Docket No. 52-001

SUBJECT: FINAL REPORT TO DOCUMENT THE DISPOSITION OF THE IIRG COMMENTS
ON THE GE NUCLEAR ENERGY (GE) ADVANCED BOILING WATER REACTOR
(ABWR) INSPECTIONS, TESTS, ANALYSES, AND ACCEPTANCE CRITERIA
(ITAAC)

INDEPENDENT REVIEW GROUP COMMENTS REQUIRING DISPOSITION BY GE

Figure 3.4c Anticipated Transient Without Scram (ATWS) Control Interface Diagram

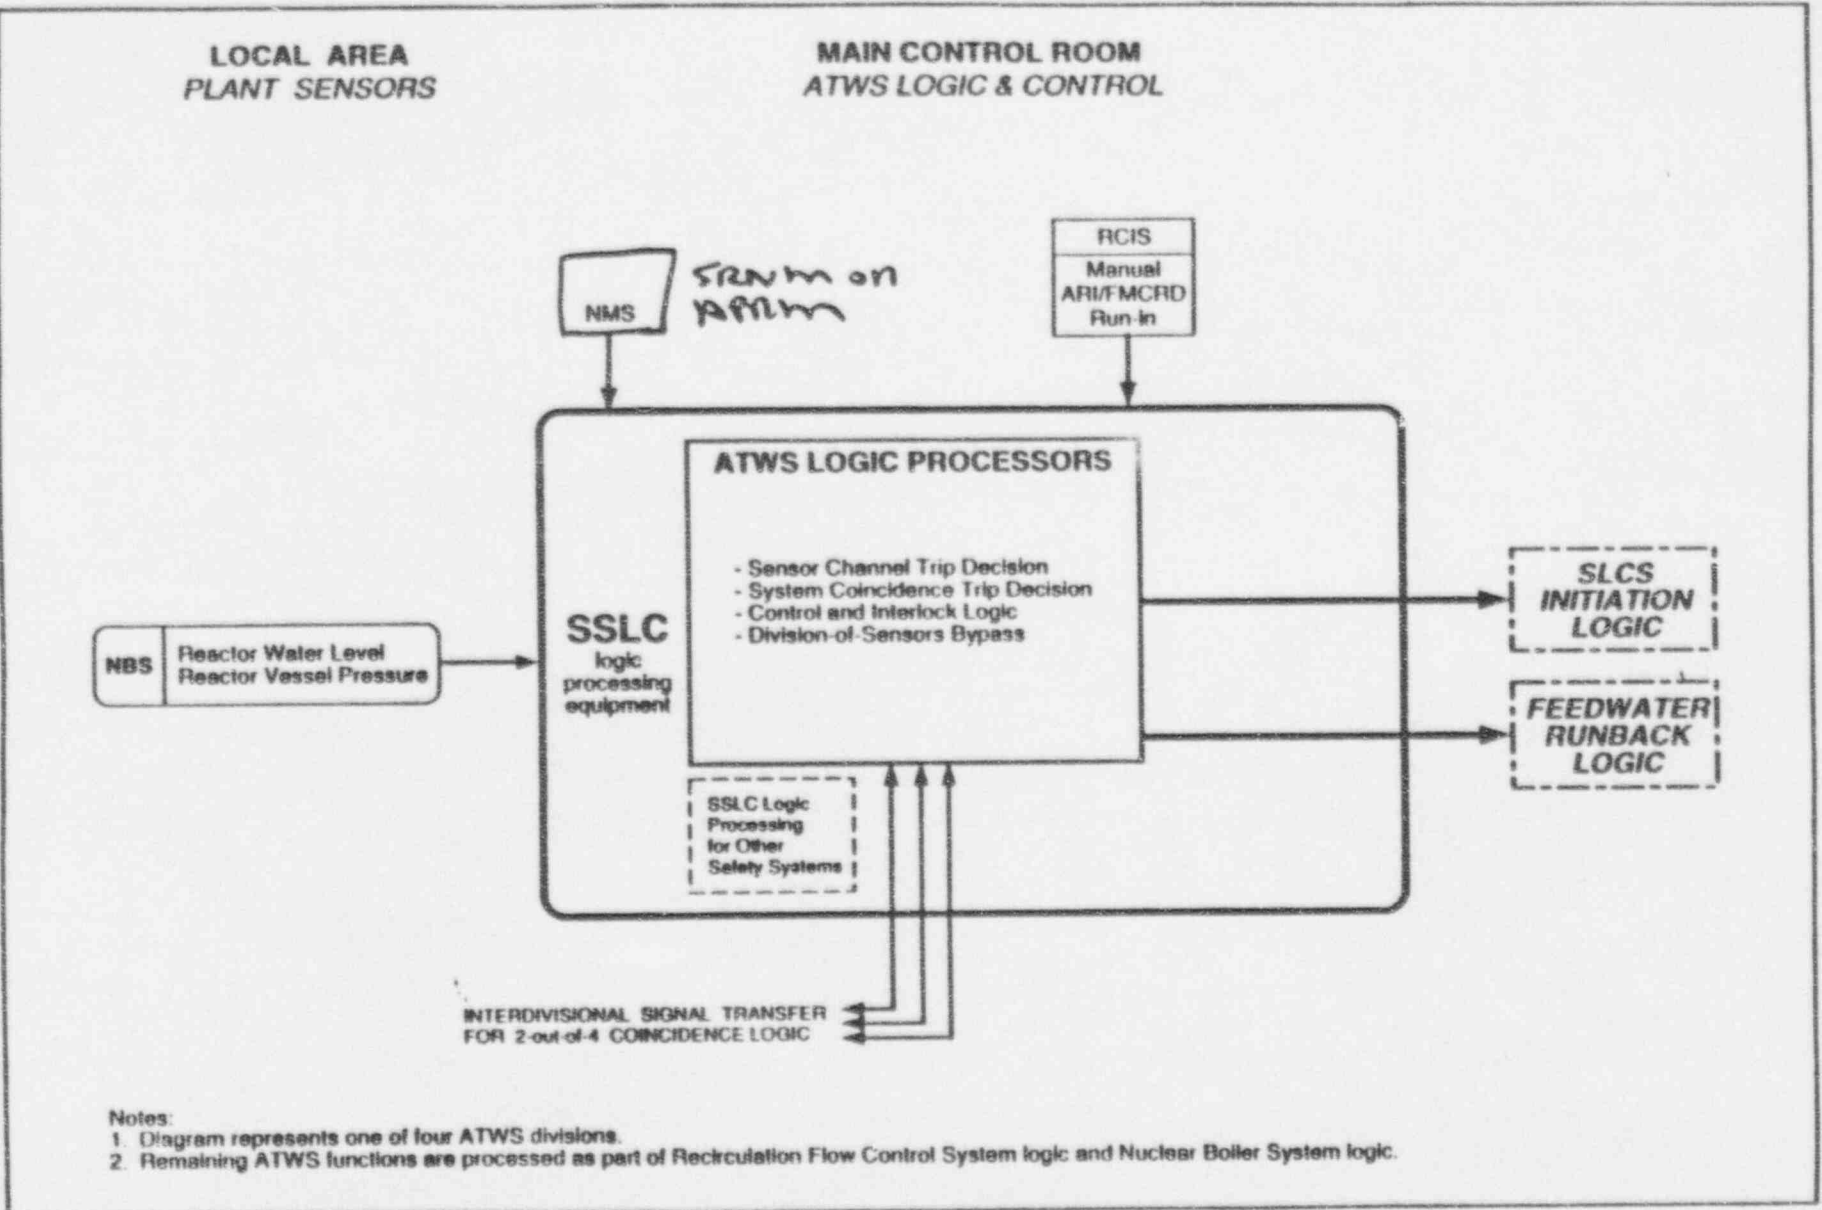
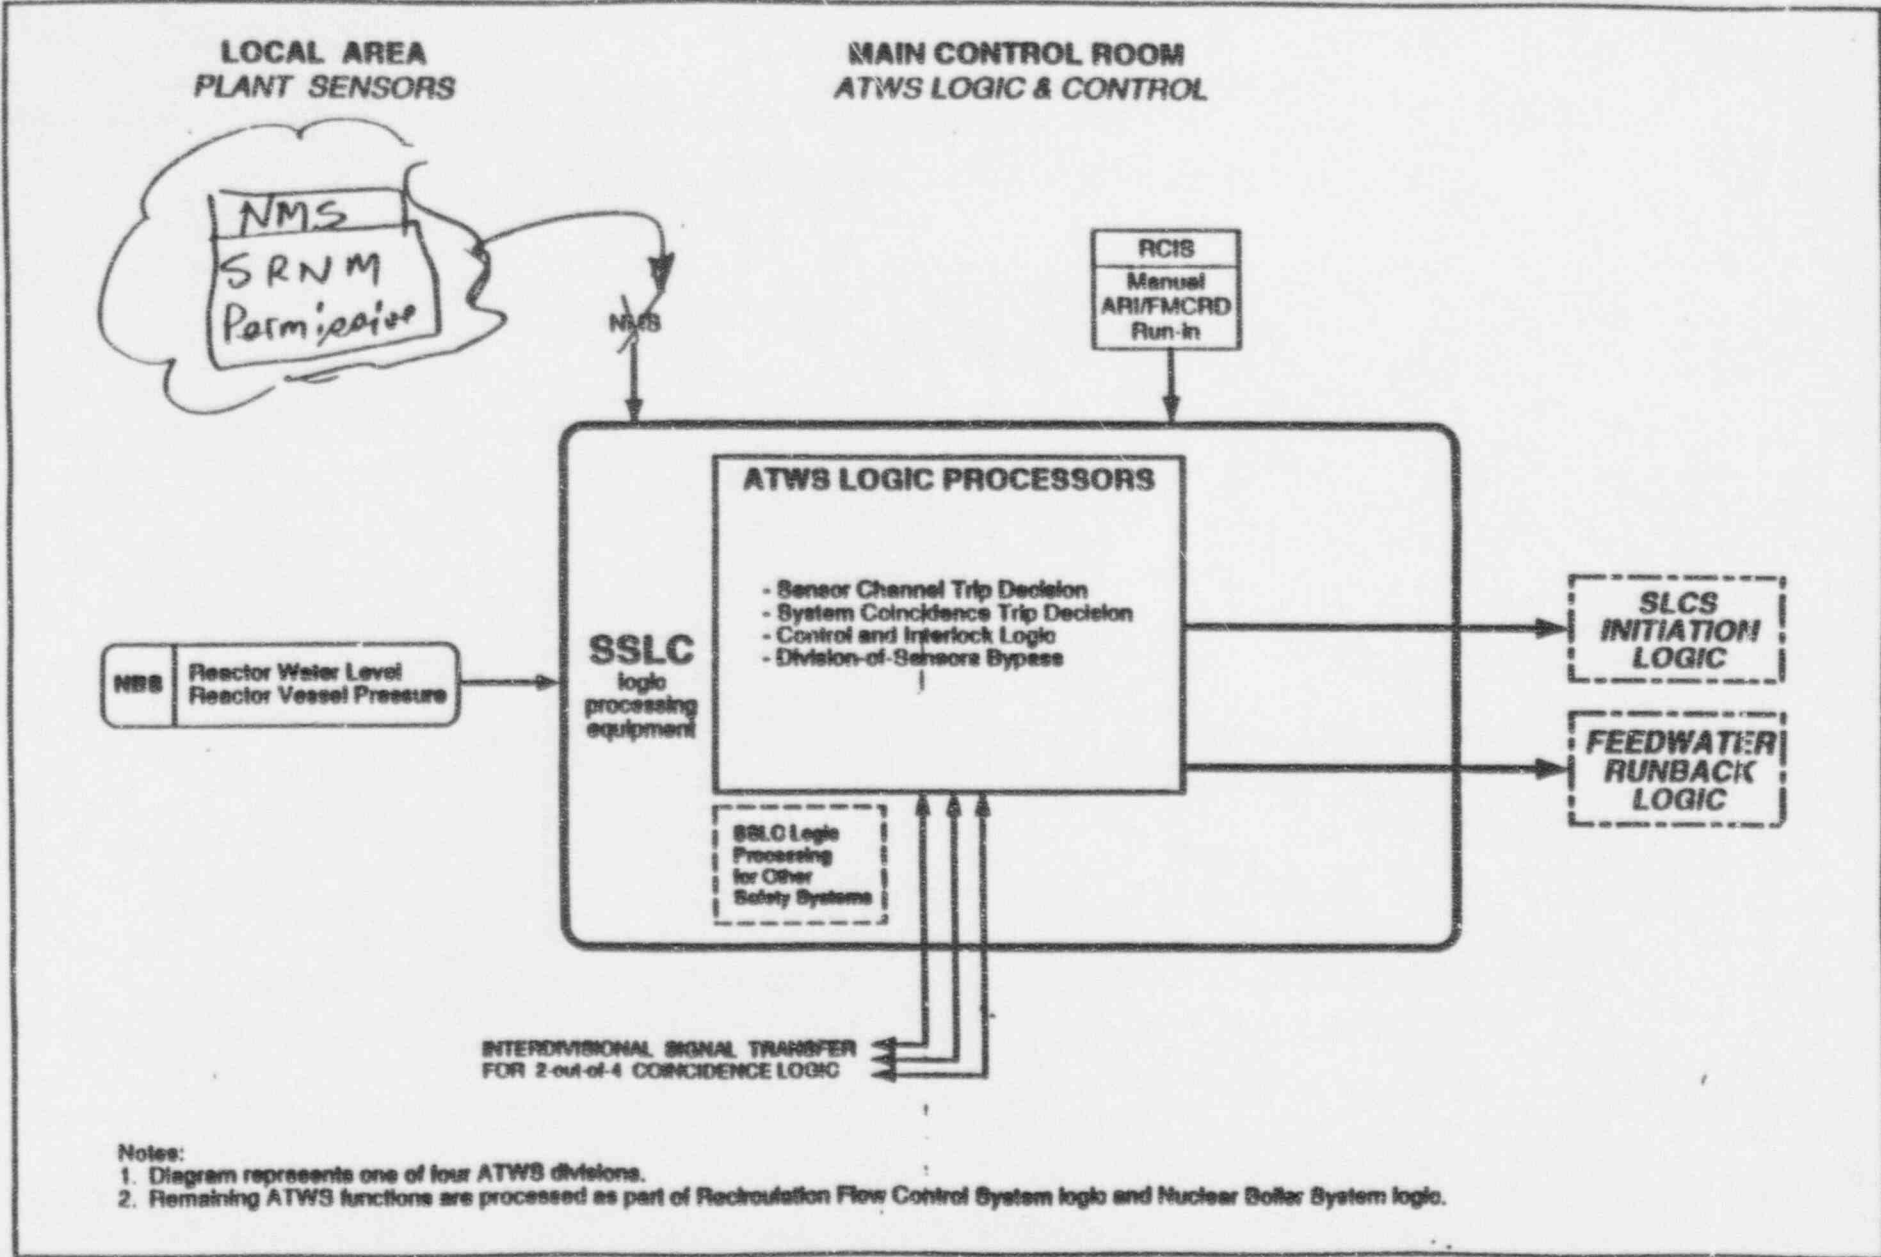
Figure 4.3c, page 3.4-19 "NMS" should be blocked in with input designated to be consistent. See attached.

~~Later~~ GE concurs that the NMS acronym should be enclosed in a box and should indicate that the signal is an ~~SP~~ NMS permissive. The attached changes will be included in the next revision of 25A5447.

Figure 2.2.7a Reactor Protection System Control Interface Diagram

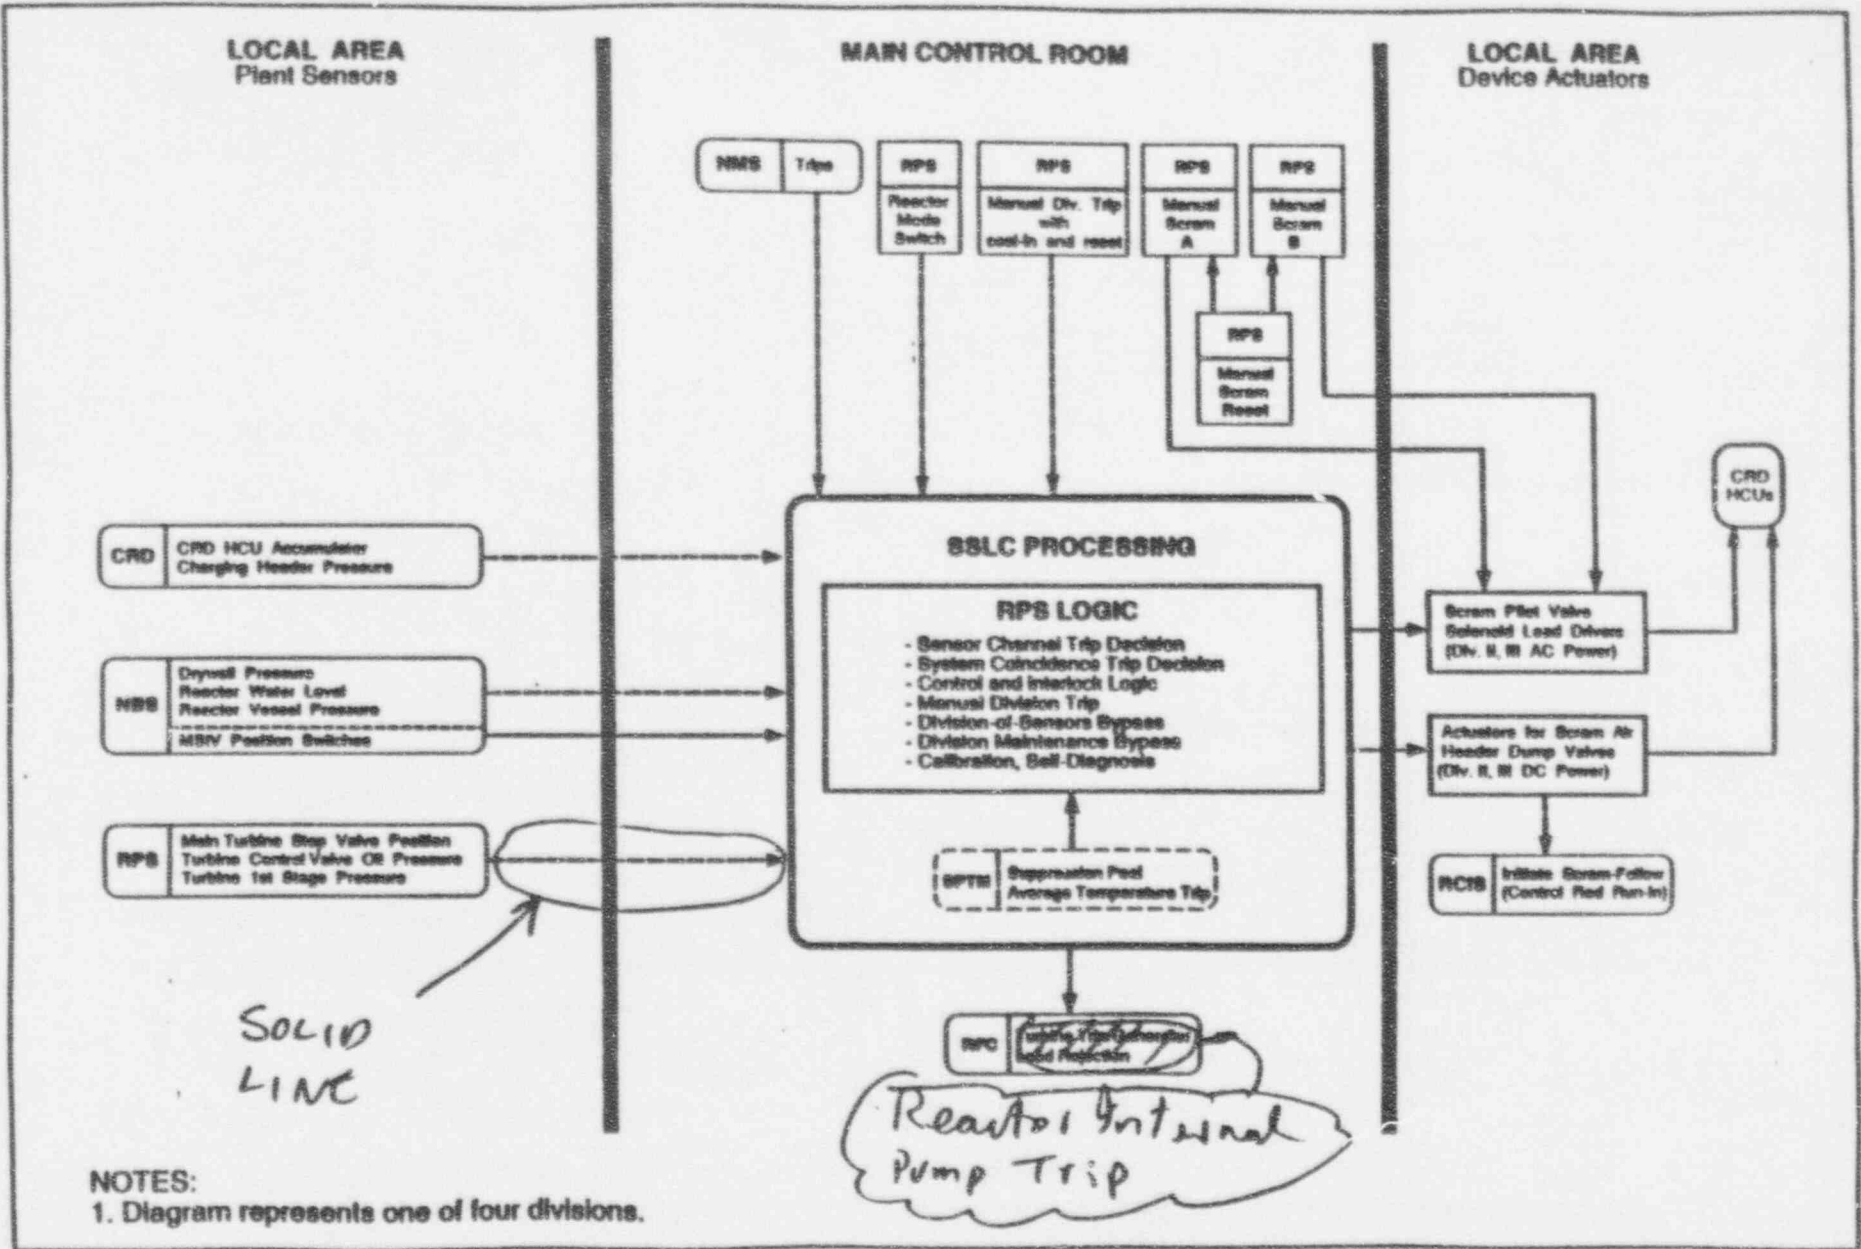
Reactor Protection System design description 2.2.7 does not list a reactor trip for high main steamline radiation. ITAAC states that a simulated process variable input will be used (as listed in 2.2.7 and figure 2.2.7a) to test the RPS channel inputs.

GE will clarify the CDM in this area by including the attached change in the next revision of 25A5447.

Figure 2.10.23 Circulating Water System

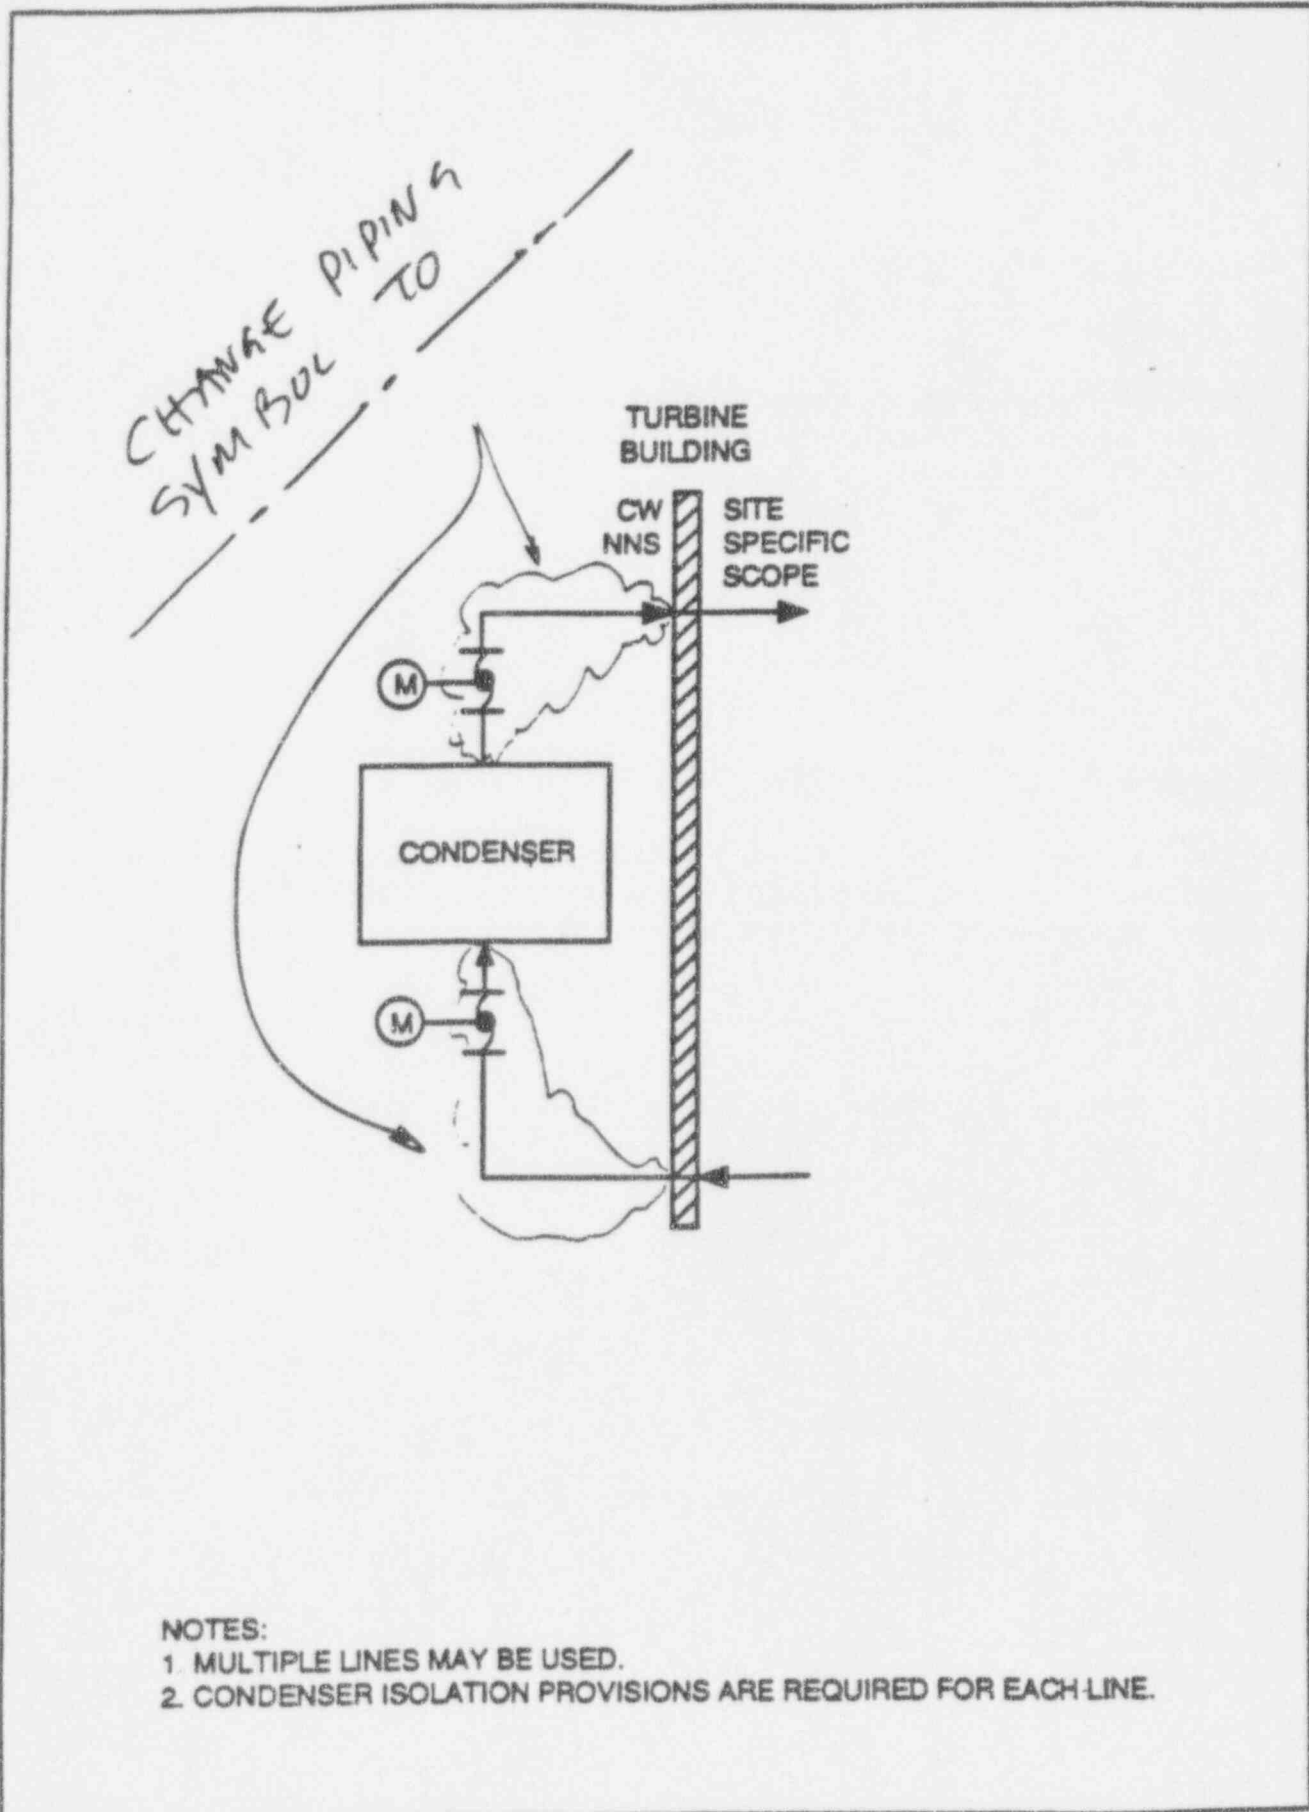
Revise ITAAC figure 2.10.23 to conform with CDM "Appendix A" for "NNS" piping class.
